**Meeting:** 1/16/2025  
**Applicant:** Elizabeth Gunn and Bryan Hill  
**Owner:** Elizabeth Gunn and Bryan Hill

**Location:** 243 Deaderick Ave. **Parcel ID** 94 F K 025  
**District:** Mechanicsville H  
**Zoning:** RN-2 (Single-Family Residential Neighborhood)  
**Description:** Queen Anne, Eastlake, and Tudor, c. 1888

**1-B-25-HZ**  
**APPLICATION FOR CERTIFICATE OF APPROPRIATENESS**

# Chimney Removal

Northwest  
Chimney

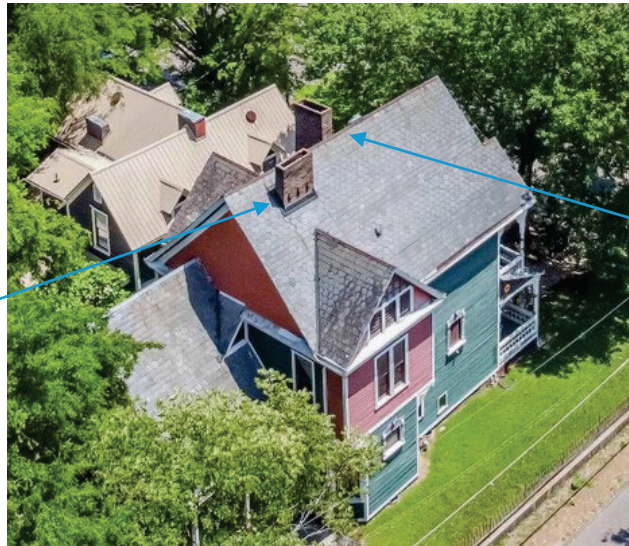
1. 243 Deaderick Avenue is a contributing resource to the Mechanicsville National Register District and the local overlay.
2. The scope of work includes the removal of the original northwest chimney and the installation of new architectural roof shingles in its place. The guidelines prohibit the removal of original chimneys, and there are no cases in Mechanicsville that set a precedent allowing for the removal of original or non-original chimneys. In two of the three cases involving chimney removal in Mechanicsville, the scope was denied outright (12-M-12-HZ). This includes a case (8-G-11-HZ) where replacing the chimneys was cost prohibitive, and the staff report indicates the alternative is “simply leaving them in their present condition until they collapse.” The third case (6-E-14-HZ) was an after-the-fact review where the chimney stack heights had been reduced, and the applicant was allowed to remove all three chimneys, reconstructing two and fully removing the rear cooking chimney.

Northwest chimney has been determined by our contractor to be unsafe and beyond repair. We are requesting approval to remove the chimney to the roofline and have the new shingle continue in its place. Contractor provided a quote to rebuild the chimney to a safe standard and the quoted fee is cost prohibitive. Photos of the deteriorated chimney are below.

Staff recommends denial of the removal of the northwest chimney, and recommends repair and/or reconstruction of the chimney, with details to be approved by staff.
